Subject: McGuire Nuclear Station
Docket Numbers 50-369 and -370
Catawba Nuclear Station
Docket Numbers 50-413 and -414
Technical Specification Revision to Change Method of
Measuring Reactor Coolant System Flow Rate; Supplemental
Information

REQUEST FOR ADDITIONAL INFORMATION
REACTOR COOLANT SYSTEM (RCS) FLOW MEASUREMENT METHODOLOGY

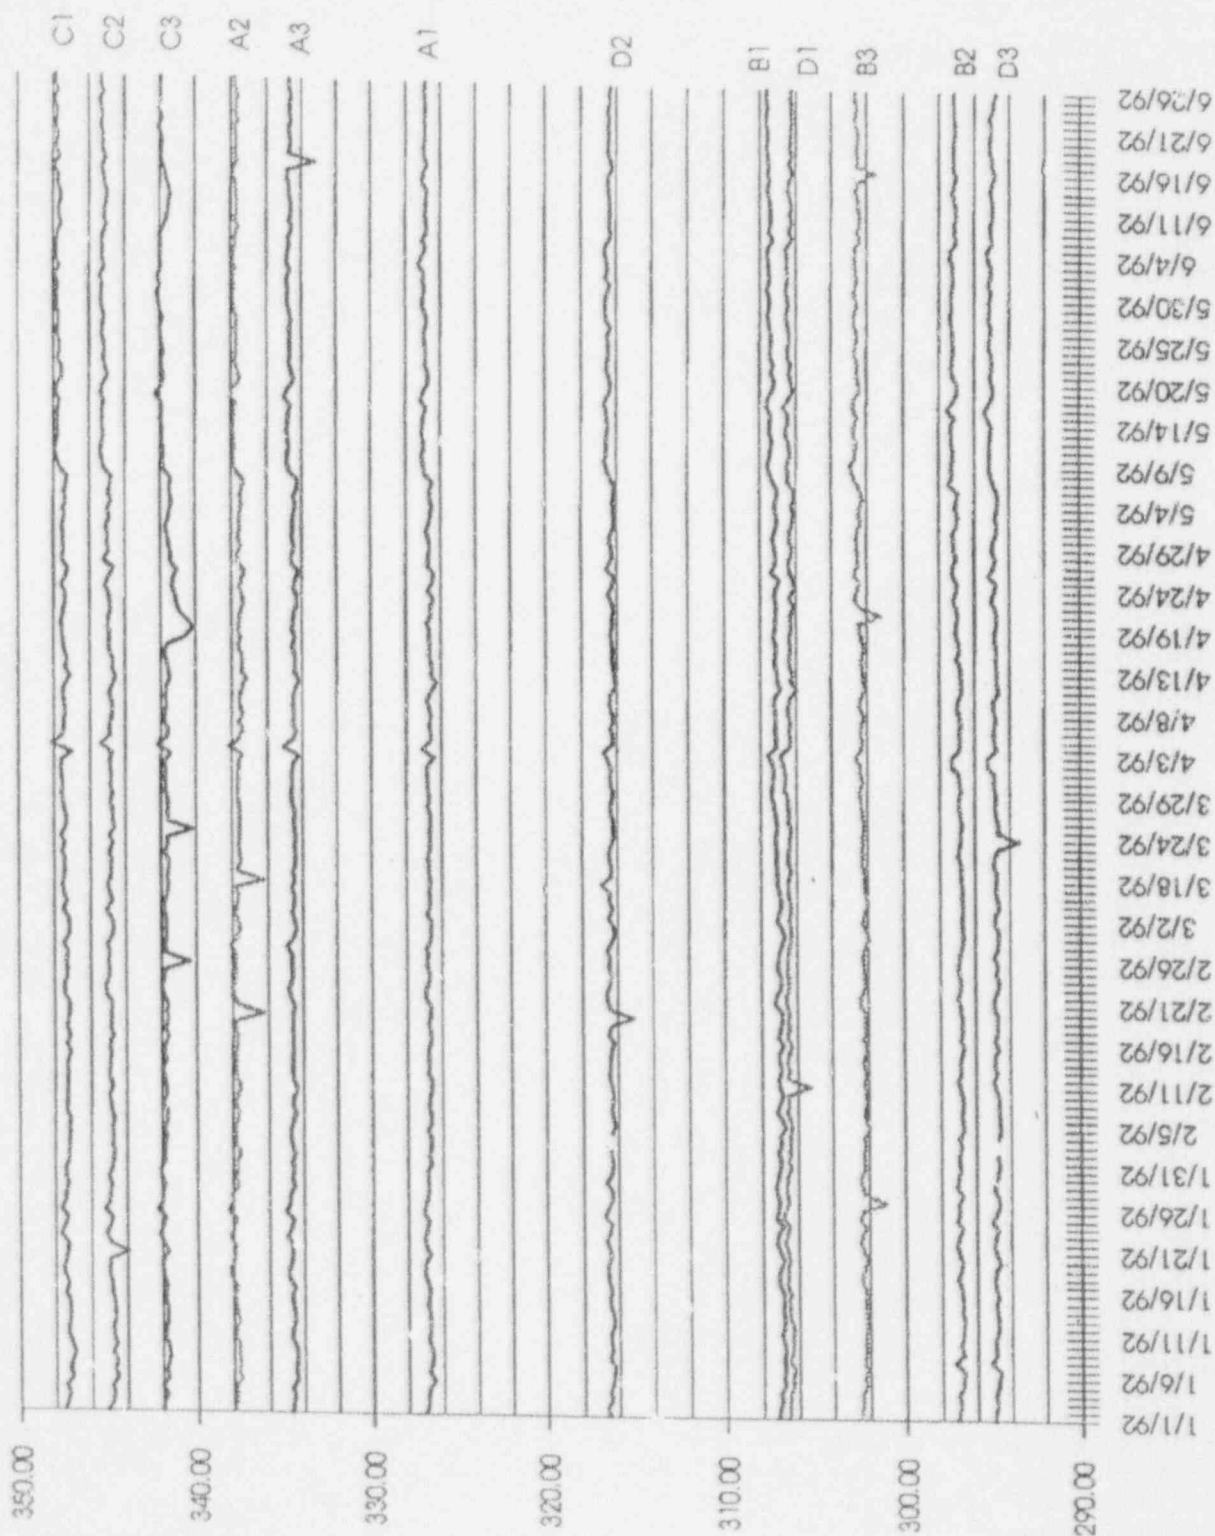
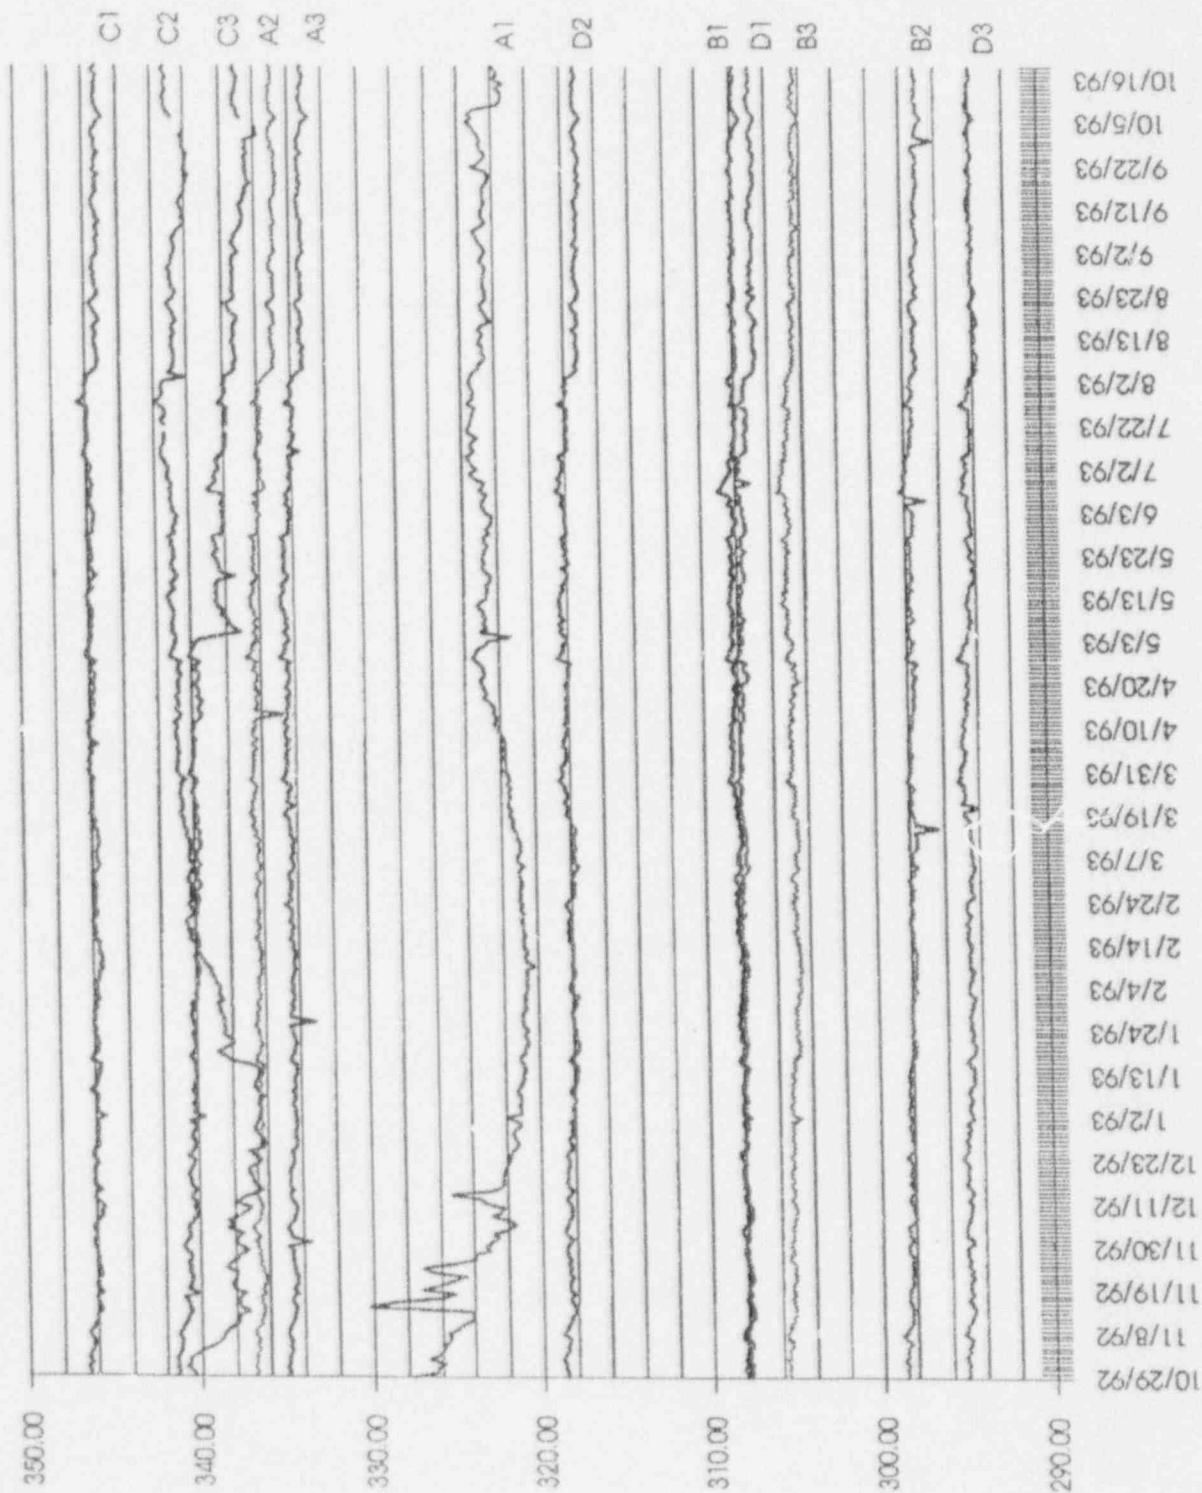
- (8) Please provide a comparison of analyses and observed RCS loop/total flow rate behavior as determined from elbow tap differential pressure indications and from calorimetric testing for both Catawba and both McGuire units. Sufficient data should be used to establish that:

Figures 18 and 19 show the daily average elbow tap ΔP data for Catawba Unit 1 back to January 1, 1992. This data covers cycles 6 & 7 and has been modified to eliminate bad data and data at off power days ($<99\%$ power). The data shows that the elbow tap ΔP s are very steady with no major drifting trends when the transmitters are operating properly. Channels A1, C2, and C3 did have drift problems during cycle 7 and were replaced during the last outage. In addition, the OAC scanner was recalibrated on August 5, 1993 which resulted in decrease in ΔP of approximately 0.3% in each channel. The numerous random small dips in the ΔP indications are the result of a bad data point in the daily average. Occasionally a point will read invalid by the computer and this will be recorded as a zero reading for the 5 minute period in question. This causes the daily average for that day to read slightly low resulting in the small dips in the elbow tap ΔP s.
